Subject: CU South Annexation

Date: 6/28/2021

Boulder County's Department of Community Planning & Permitting has the following comments related to the materials that we have reviewed related to the annexation, the City of Boulder Annexation Briefing Book dated April 2021, Version 2 and the Traffic Impact Study.

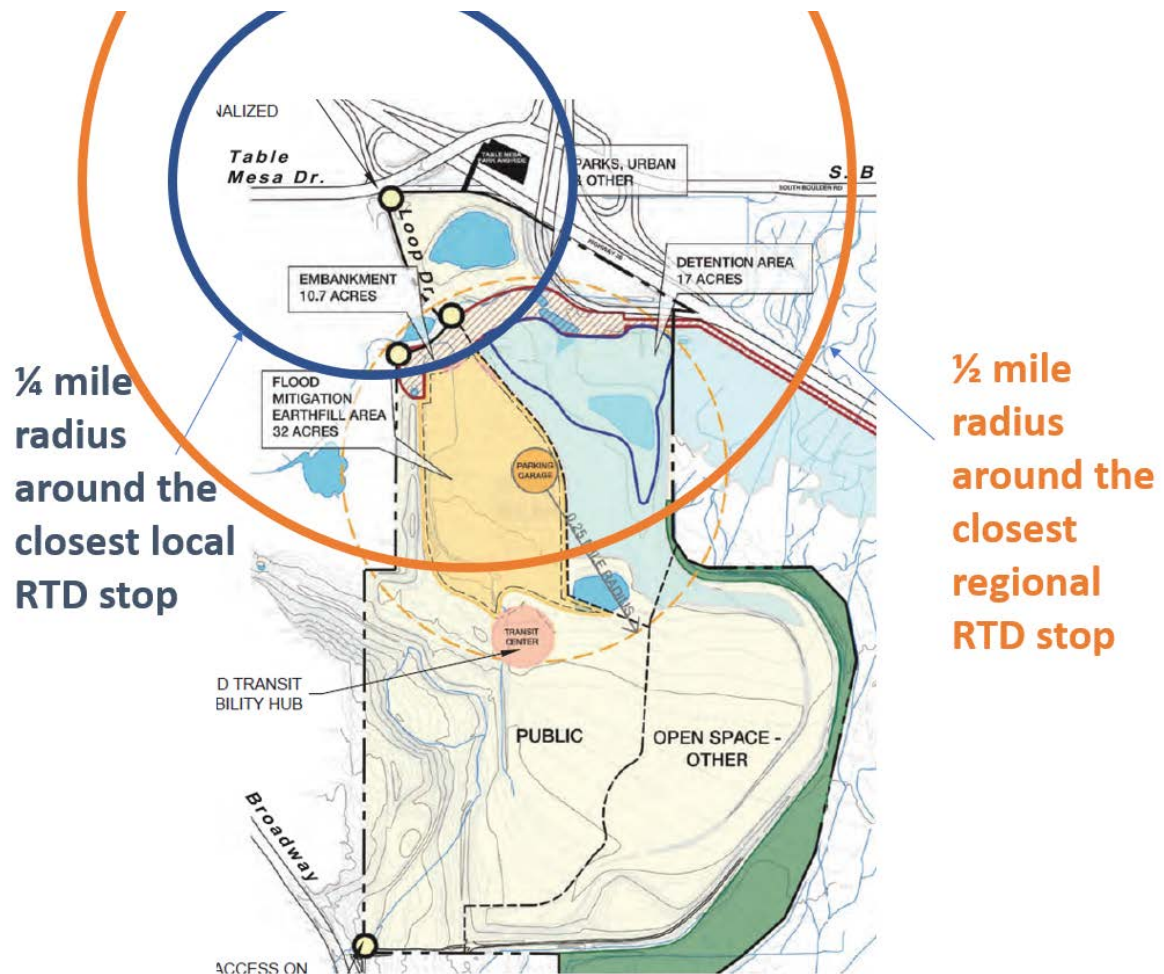
Boulder County developed a map to look at the elevation difference between the proposed intersection and 600 feet to the north, measured on the centerline. The elevation change is 25' (5478' – 5453') which over 600' is a grade is 4.2%, triggering an adjustment factor of 1.2.

Thus, according to CDOT's access code the required visibility to the north of the proposed intersection should be 1,200 feet ($1000' \times 1.2$). This is about 200 feet north of the Chambers/Broadway intersection. Actual field checks should be conducted but by looking at the Google Earth photos it appears unlikely that this condition is met. Note that the Google photos are taken from the perspective several feet above the top of a car where as the access codes states the visibility should be measured at a height of 4.25 feet above the road.

Transit Priority: SB LT at Broadway & Table Mesa

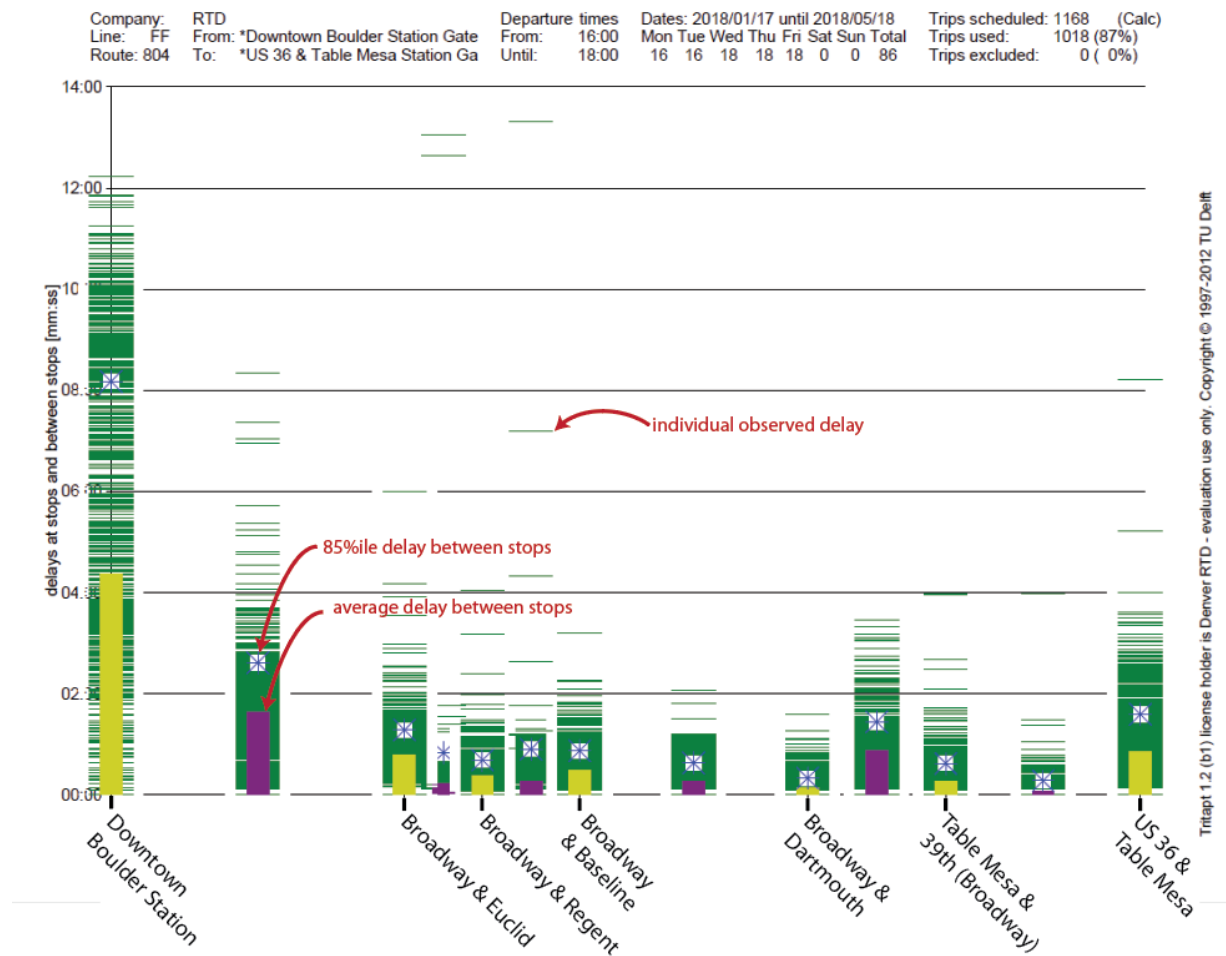
The Study recommends extending the existing southbound left turn lane on Broadway at Table Mesa by 390 feet (to achieve a 550 foot left turn lane) to avoid left turn vehicles from blocking the through lanes. This proposal will not achieve the City's goals of increasing transit mode splits, particularly for regional trips. The DASH to Louisville/ Lafayette, the AB to the airport and the FF1, FF2 and FF5 to US36 destinations and Denver all use this left turn. The photo below is taken looking south just south of Dartmouth & Broadway and shows four buses stuck in PM peak hour traffic. The graphic below shows that the section between Broadway & Dartmouth and Table Mesa & 39th is one of the highest delay points in the whole Broadway/Table Mesa corridor. In fact, 85% of transit trips are delayed about 1 ½ minutes in this section.

Capital improvements are needed that provide transit users with a distinct travel time savings over a private car. Below is an example of how this could be achieved. Not only would this help the existing RTD routes, it would also help the proposed new CU-operated bus routes. This may be the best opportunity the City has for a developer to help pay for these improvements.
